Company	Trenz Electronic GmbH
PCN Number	PCN-20210510
Title	KK0803-03A to KK0803-04 Hardware Revision Change
Subject	Hardware Revision Change
Issue Date	2021-05-14

2.1 #1 Changed milled height profile.

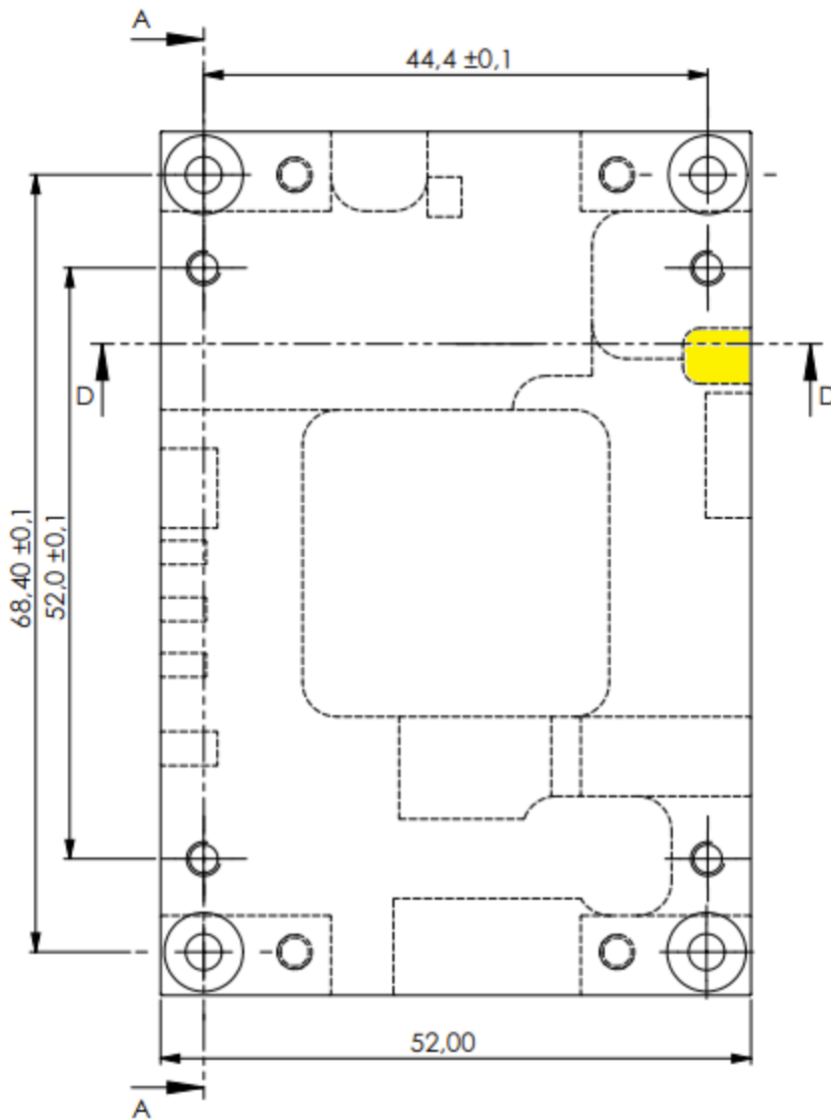
Reason: Revision 04 of TE0803 has different skyline and is therefore mechanical not compatible with KK0803-03A.

Impact: New heat spreader is compatible with TE0803-04, but not backwards compatible to older versions of TE0803.

Models with the feature marked in yellow are revision 04. Heatspreader without that feature are of older revision and not compatible to TE0803-04.
